PLANNING & DEVELOPMENT COMMITTEE

Tuesday, July 20, 2021

To: Genesee County Planning
Planning and Development Committee
Zoning Board of Appeals

Re: 204 Oak St.
Tax Parcel No. (71.014-2-5.2)

SITE PLAN AND NOTES

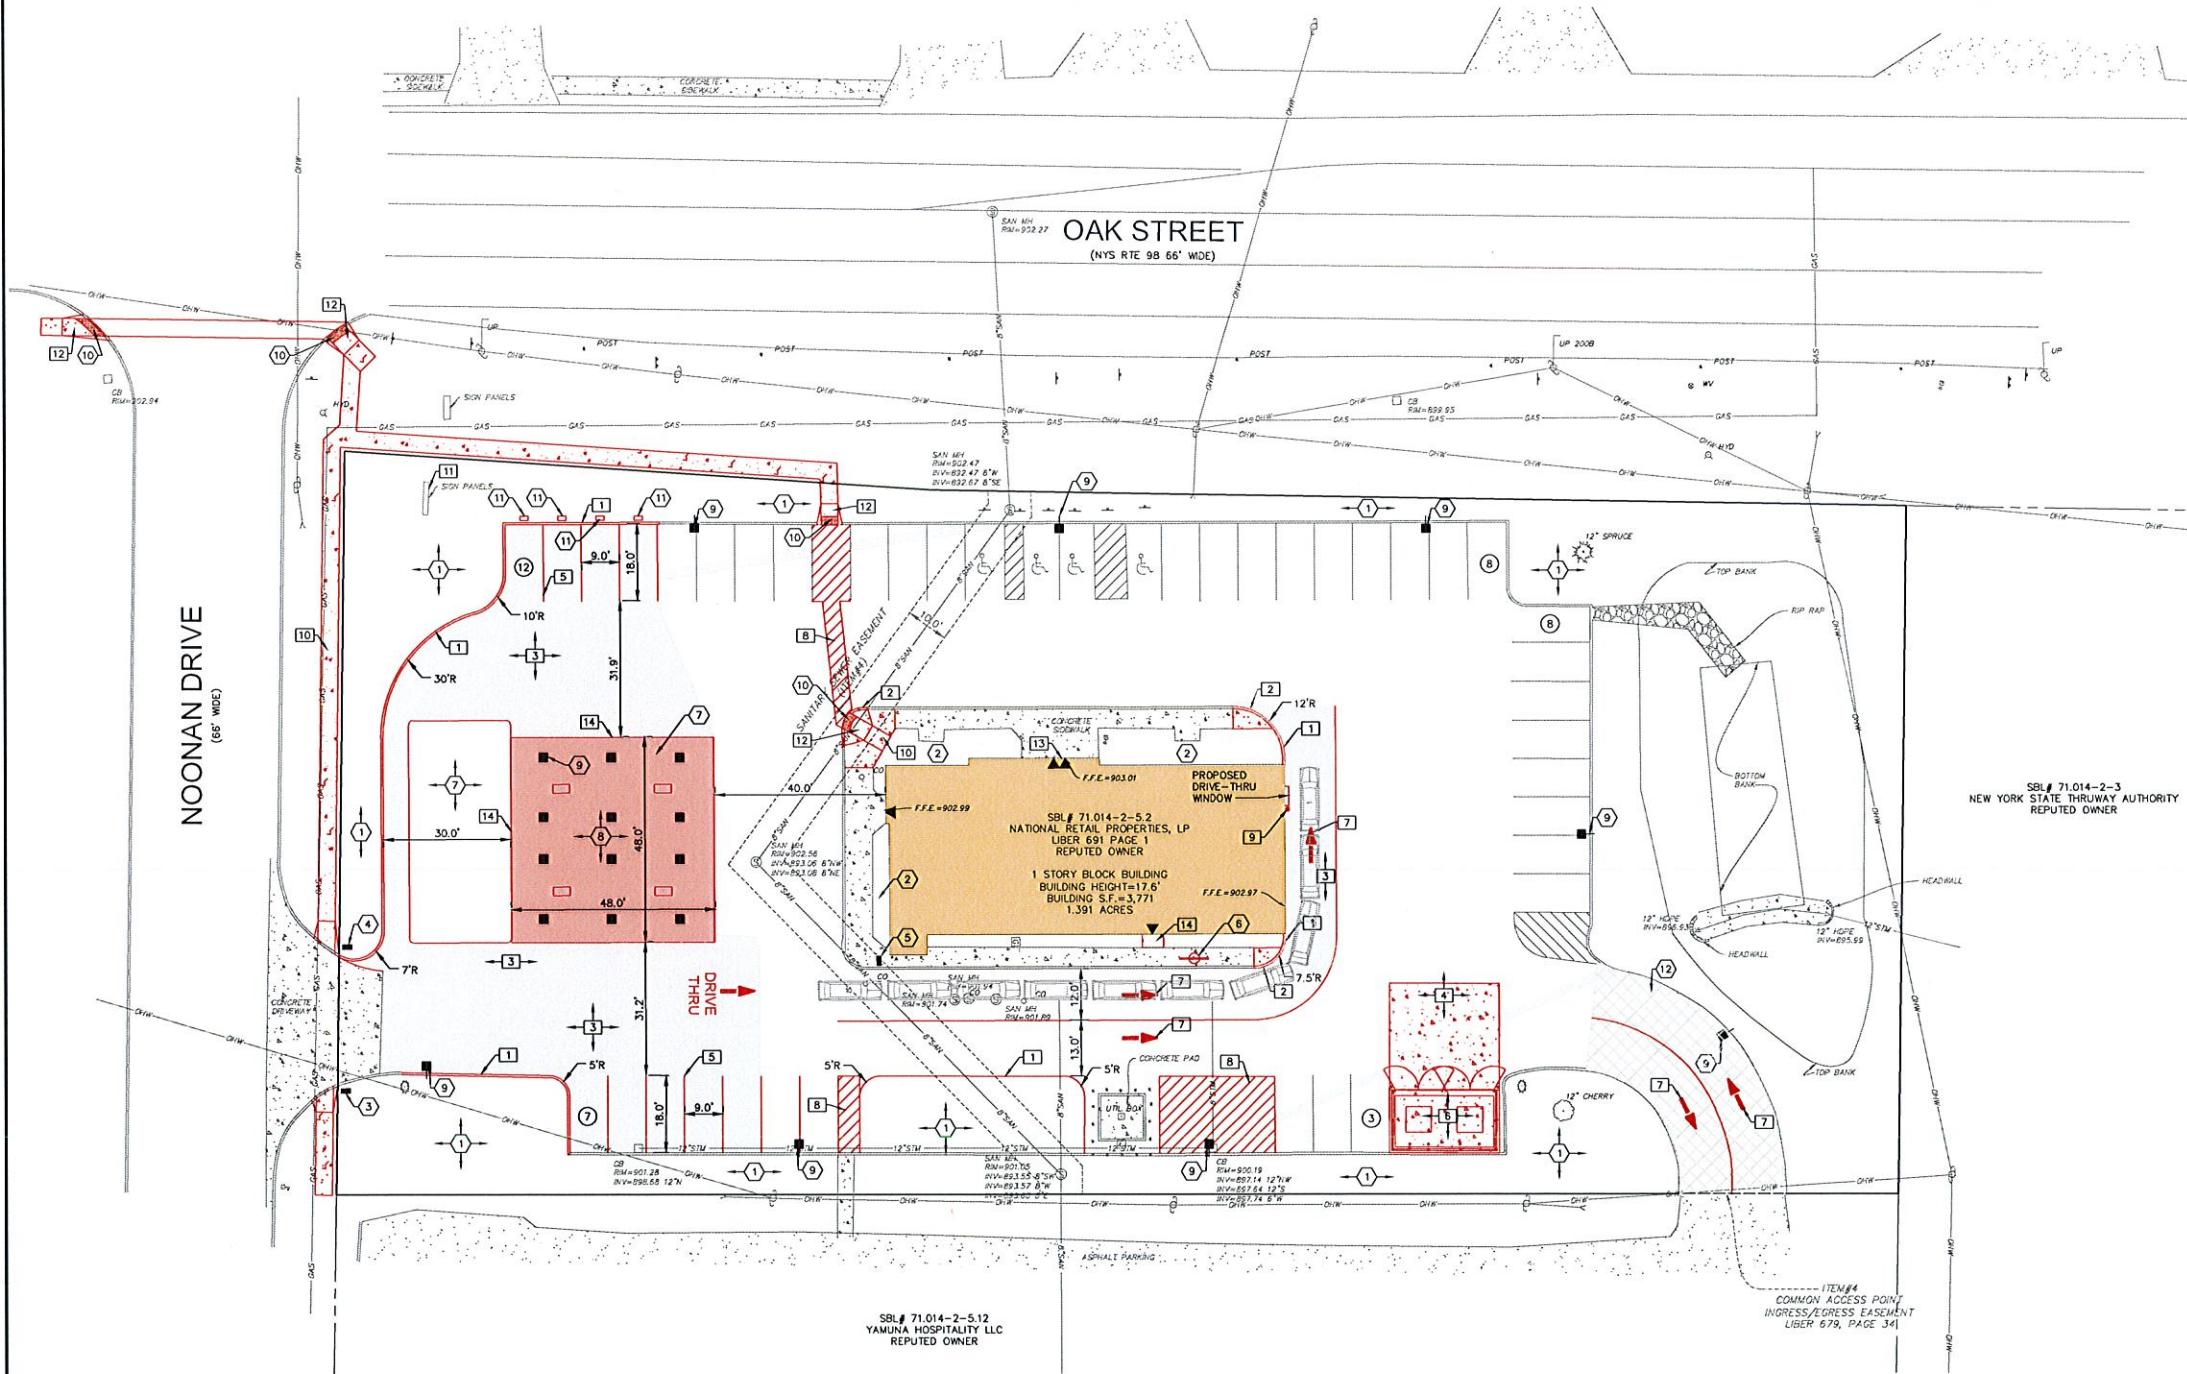
The site plan Quicklee's presented to the board was altered from the previously submitted plan, however, the traffic study was the same one originally submitted.

Mr. Beatty wanted to know how the changed site plan would affect traffic, and questioned the impact the alteration would have on the neighborhood. He pointed out that the public had not had the opportunity to comment on the revised site plan.

Mr. Preston related his concern regarding the back up of traffic from the drive-through stack. He also noted the hazard posed by vehicles attempting to exit by going around the building and the gas station pumps.

Mr. Randall asked if Quicklee's has an easement supporting their plan to have vehicles exit by way of the driveway leading to the neighboring hotel.

The board agreed that before they would be able to make a decision regarding the site plan, they would need to see a traffic study that supported the single entrance / exit on Noonan Drive, as well as the easement agreement with the hotel.

On 6/15/21 PDC reviewed SEQRA and found the proposed action will not result in any significant adverse environmental impacts, but did not approve the site plan or special use permits. The applicants were asked to provide more information regarding on site traffic flow patterns, easement agreement, and an updated traffic study reflecting the loss of the Oak St. driveway.
